**RE: Site Plan Approval for 140 Court Street; Portsmouth Housing Authority**

We hereby submit, on behalf of the Portsmouth Housing Authority, this **Response to Comments** for consideration at your July 31 TAC Committee Meeting. The response is based on the comments from the July 3 TAC Committee meeting shown below with responses in **bold text**:

SITE PERMIT PLANS  
PORTSMOUTH HOUSING AUTHORITY  
WORKFORCE HOUSING DEVELOPMENT  
140 COURT STREET  
PORTSMOUTH, N.H.

PLAN SET SUBMITTAL DATE: 17 JULY 2018

**LOT LINE RELOCATION PLAN  
 TAX MAP 116 - LOTS 38 & 37  
 FOR  
 PORTSMOUTH HOUSING AUTHORITY**

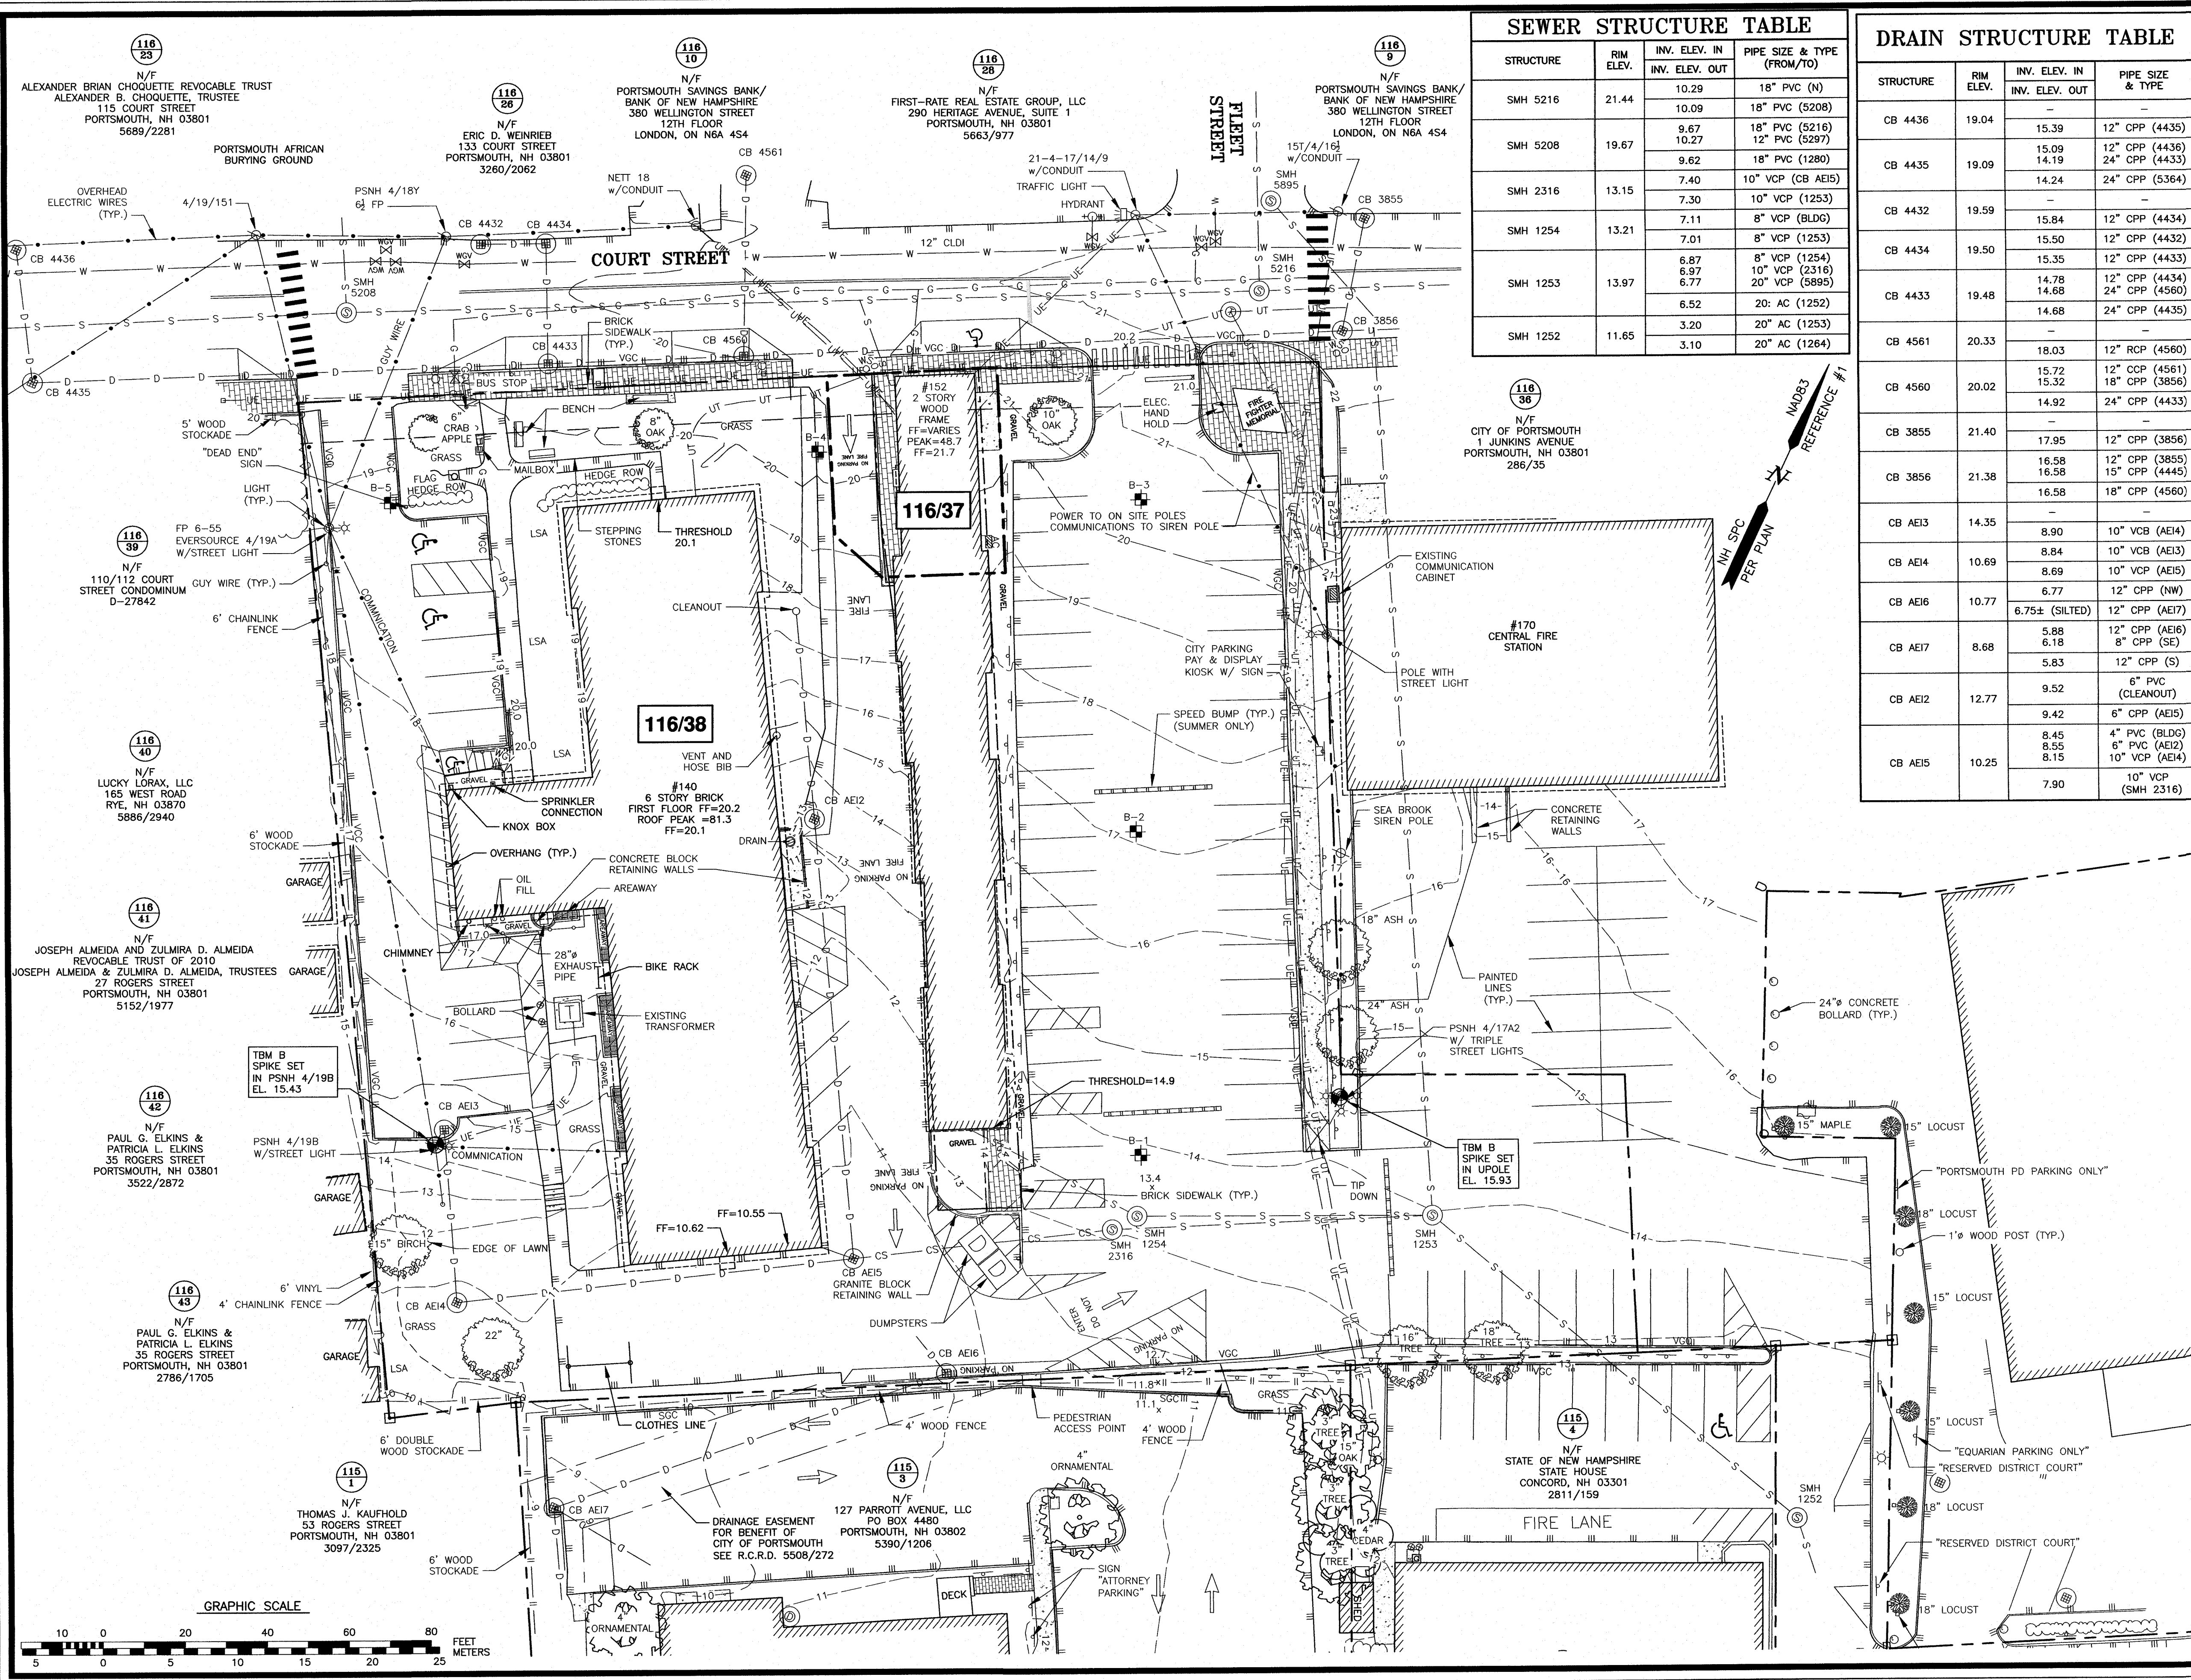
5. Comments about the proposed property line with 152 Court Street with a suggestion we adjust the angle and extend the area a couple of feet. **The property line has been adjusted as requested.**

**C4**

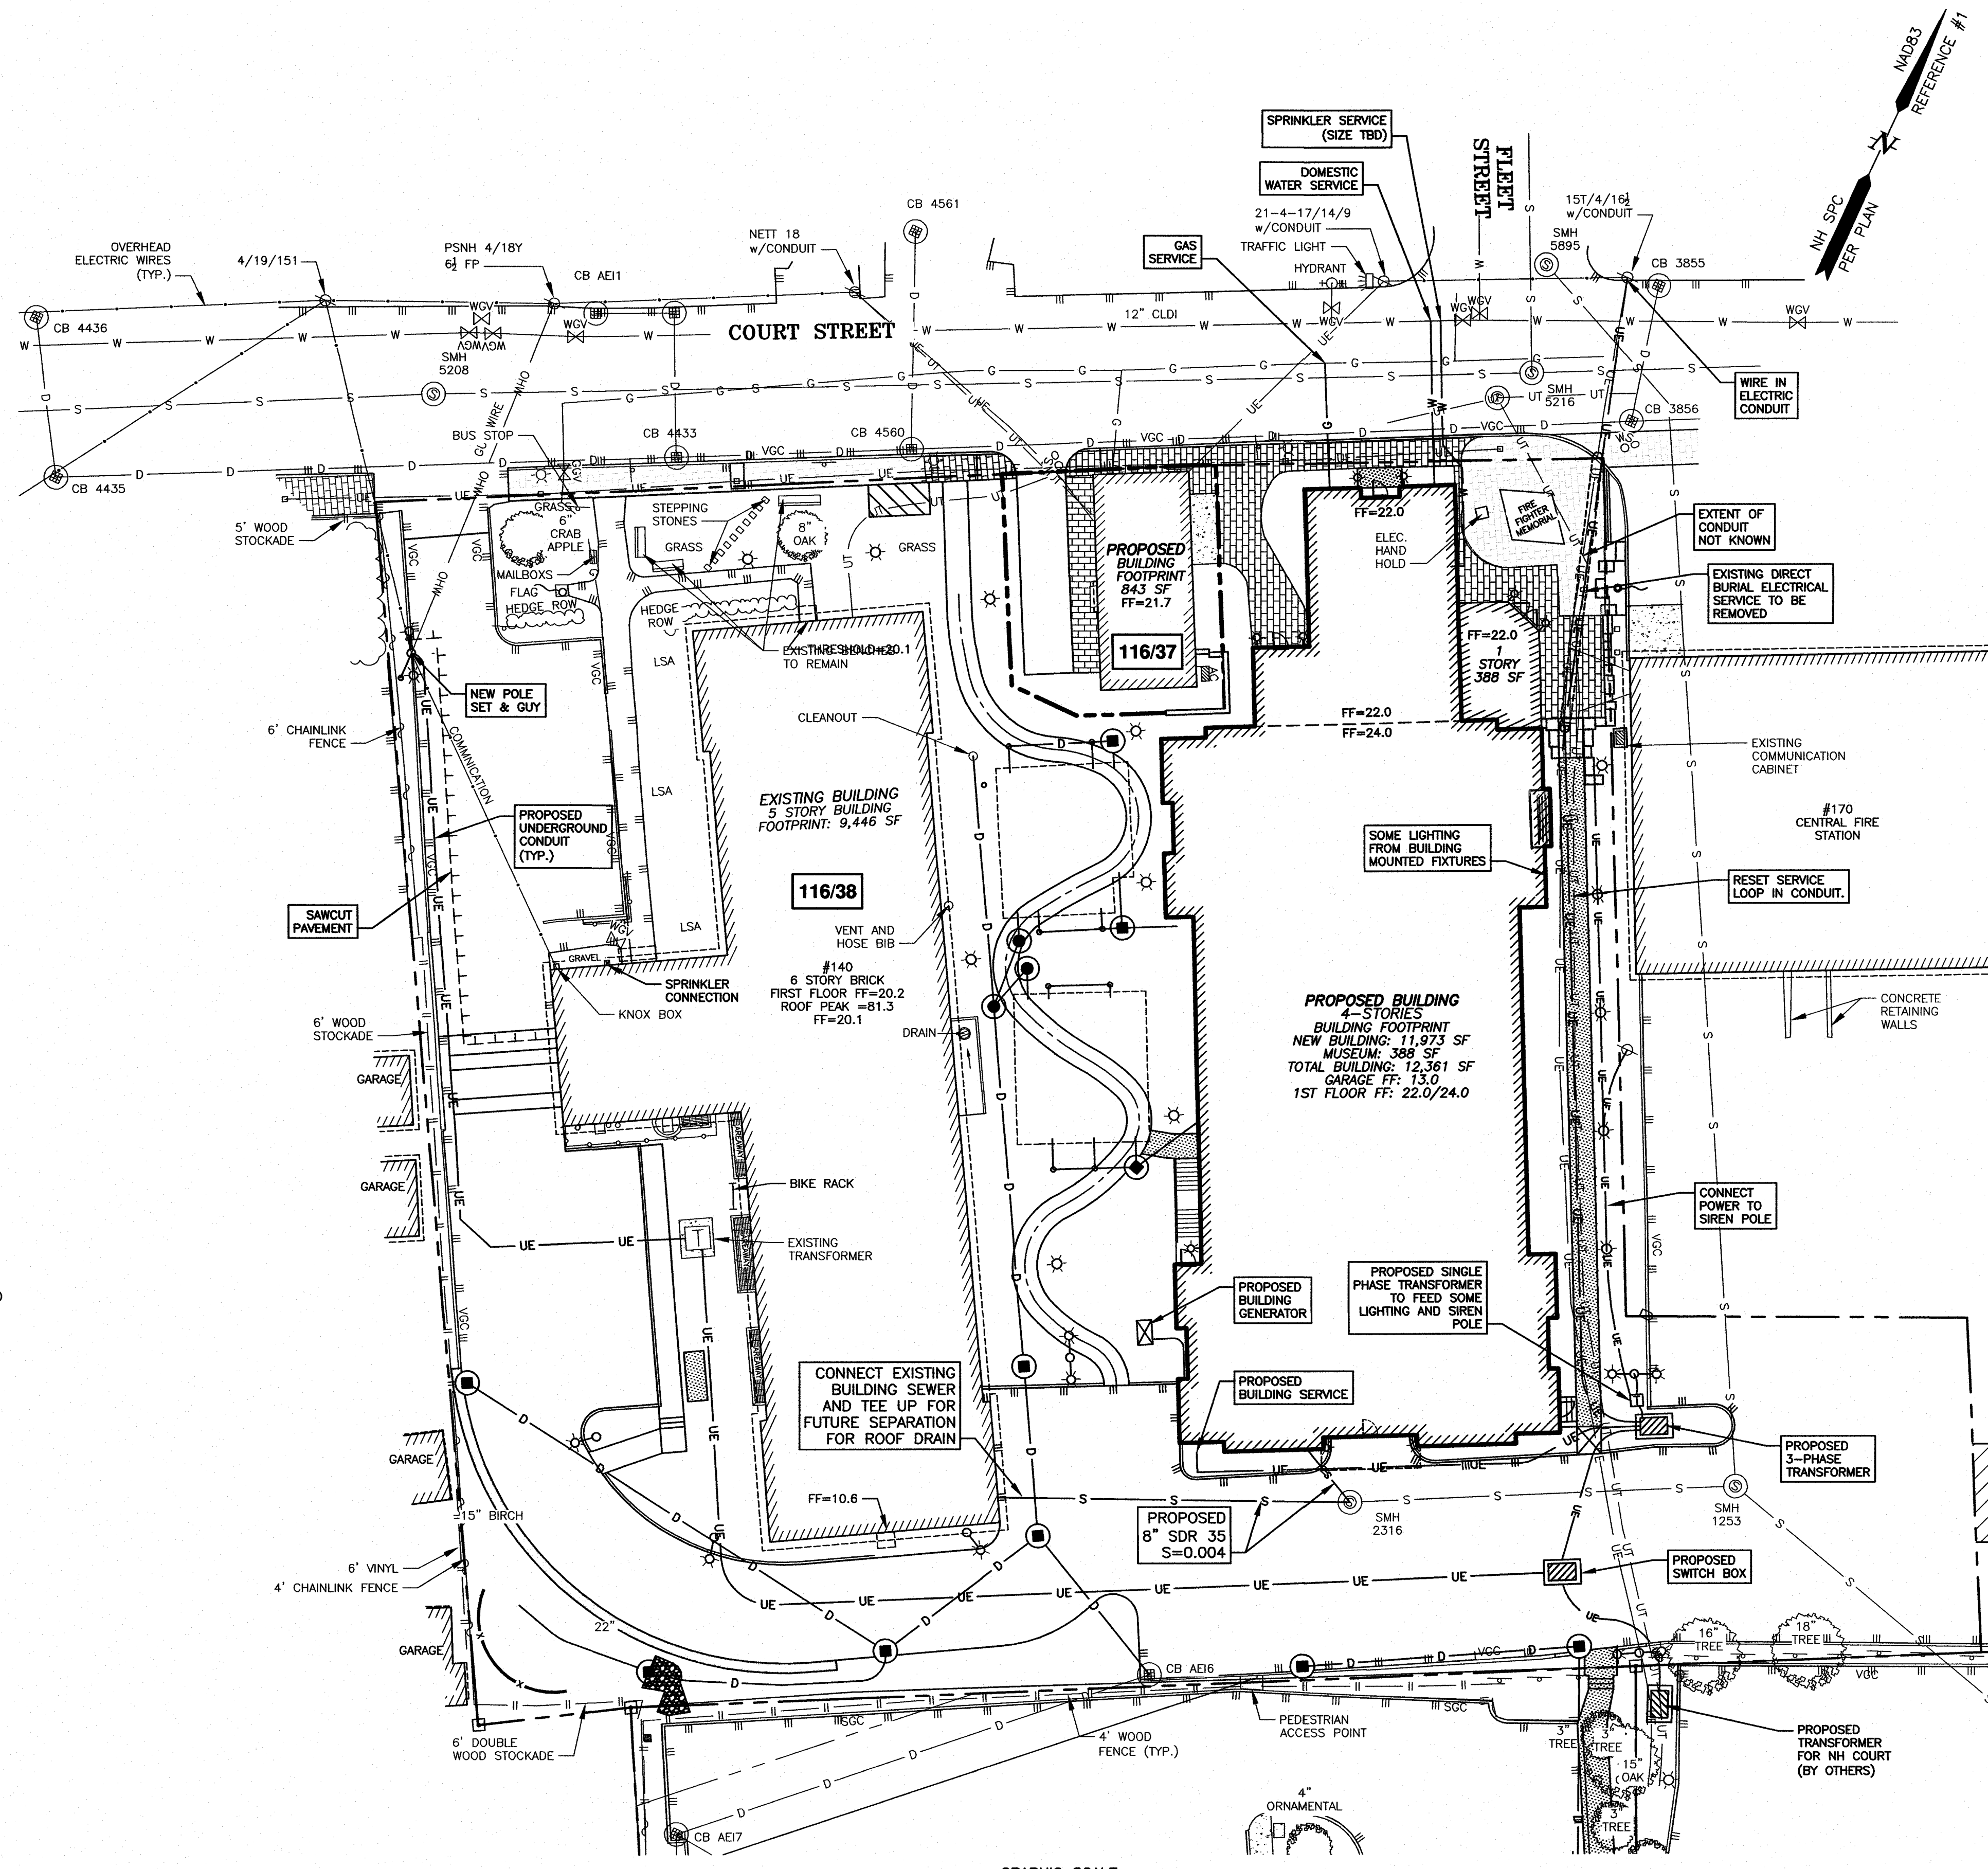
3. Door swings need to be displayed on the plans; especially Basement Plan. **Door swings are shown on the Basement Plan – Sheet C4.**
4. Basement Plan should identify uses in all rooms. **Uses are shown on the Basement Plan – Sheet C4.**

3 **FOURTH FLOOR PLAN**  
N.T.S.

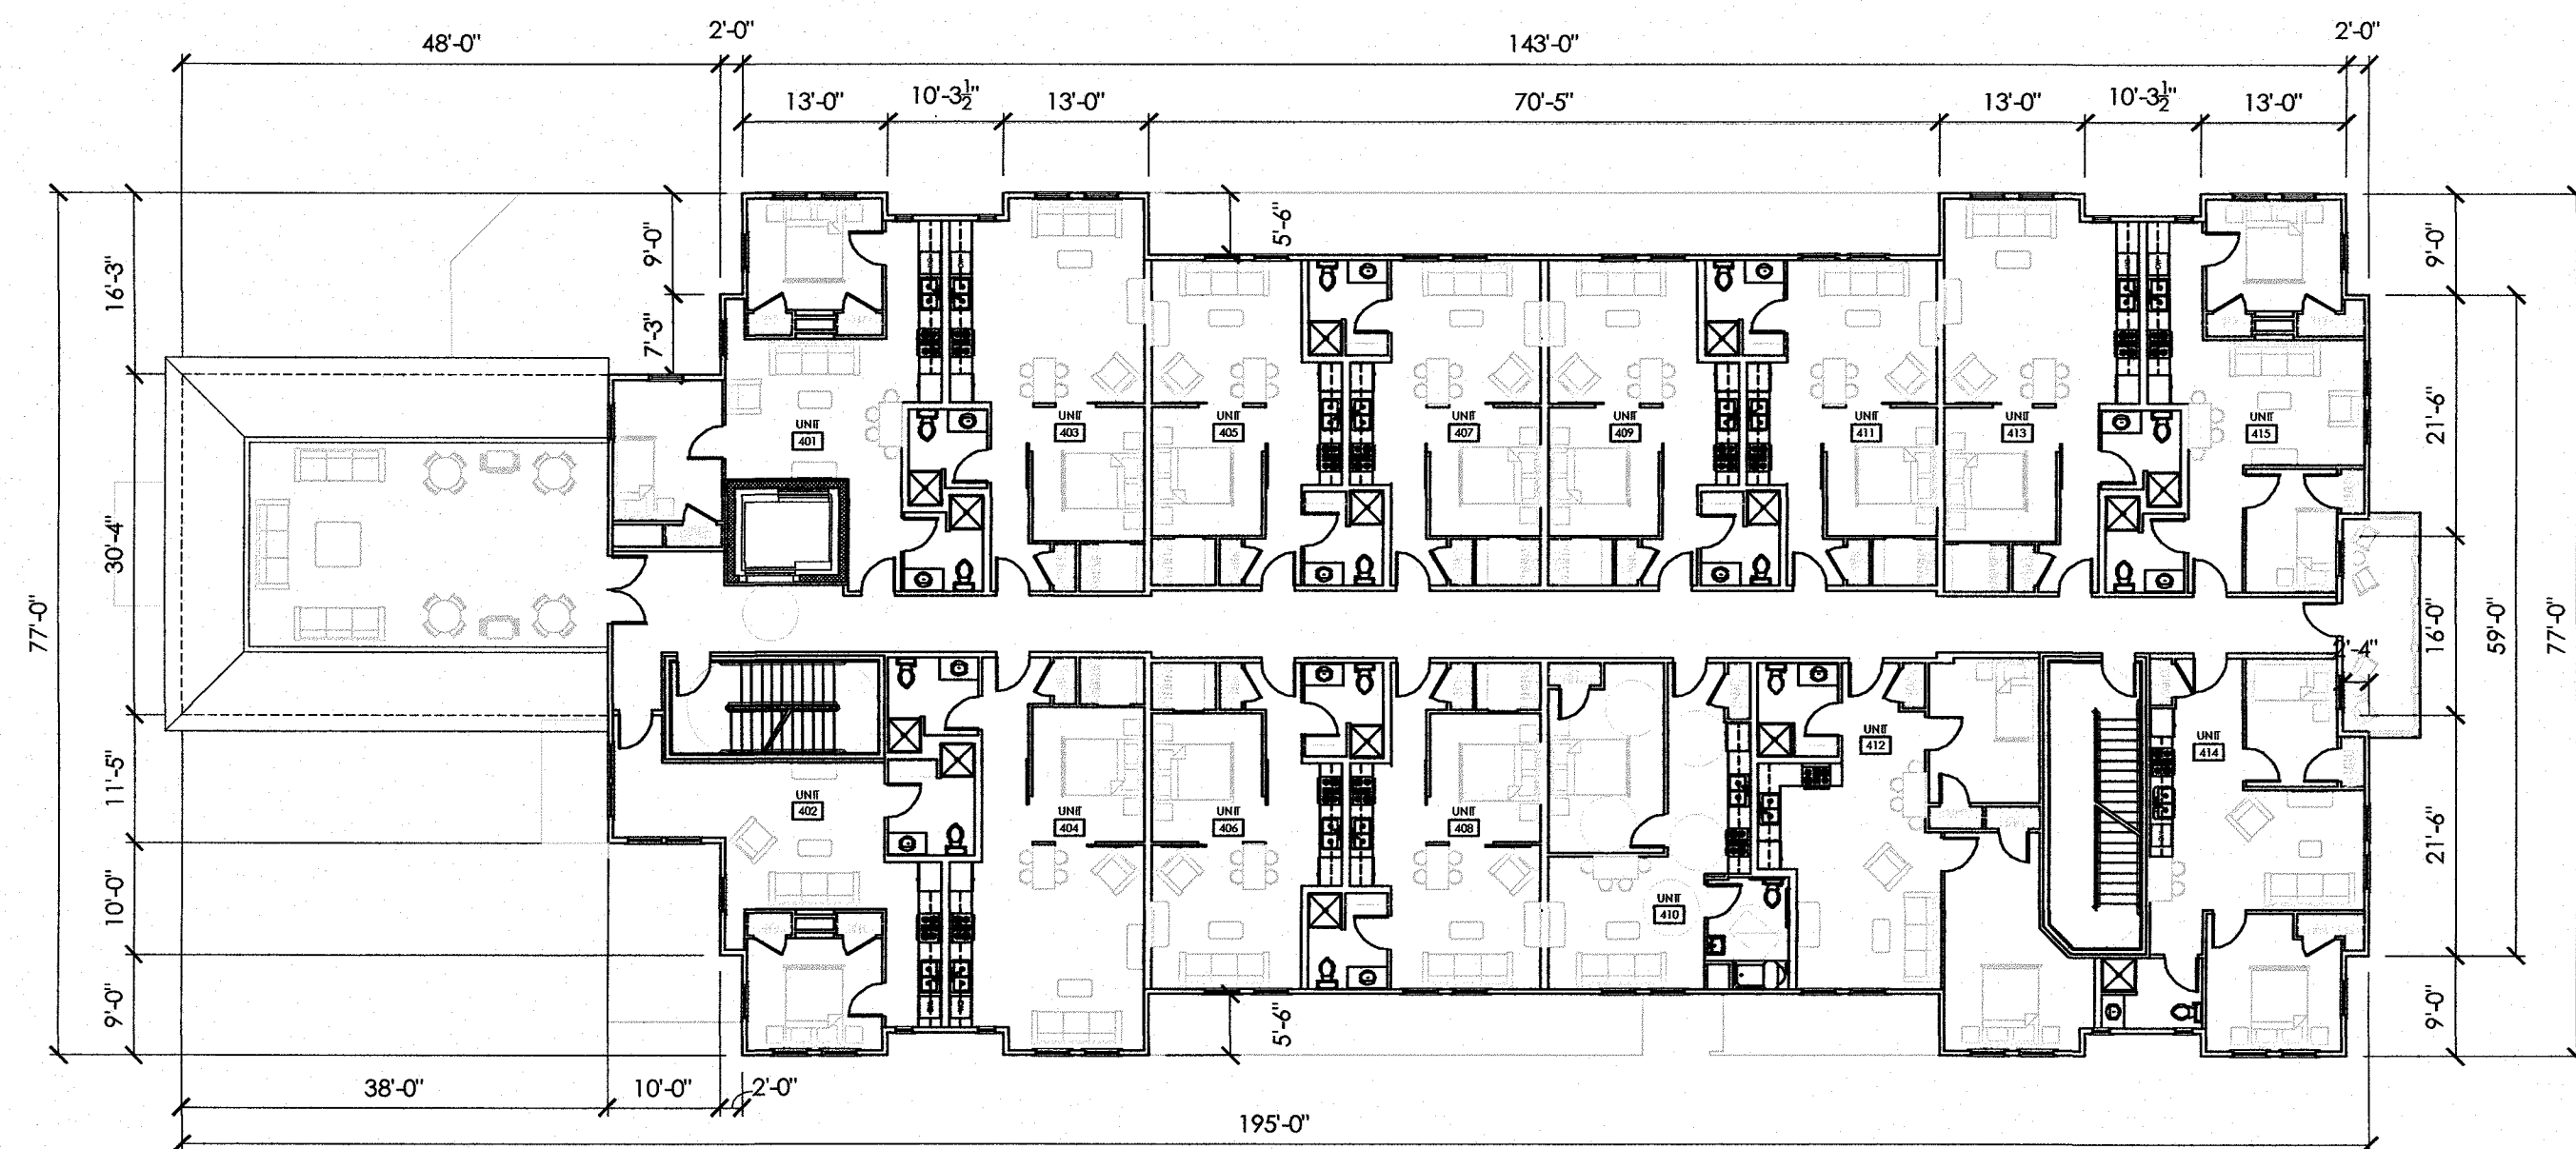
9. A Code Study should be provided for the roof deck. **CJ provided narrative included in this submission.**

In response to your inquiry during the Technical Advisory (TAC) meeting on July 3, 2018, we are providing the following analysis showing building code compliance as it relates to the 4<sup>th</sup> floor deck being proposed on the north side of the building at the 140 Court Street Development project.

The building will be a fully sprinklered building and complies with IBC 2009 section 1021.1 with 2 exits from each of the building's stories.

The proposed 4<sup>th</sup> floor deck is 584 square feet. For residential use R-2, the occupant load factor is 200 gross square feet per person, resulting in an occupant load of 3.  
(584 square feet / 200 square feet = 2.92.)
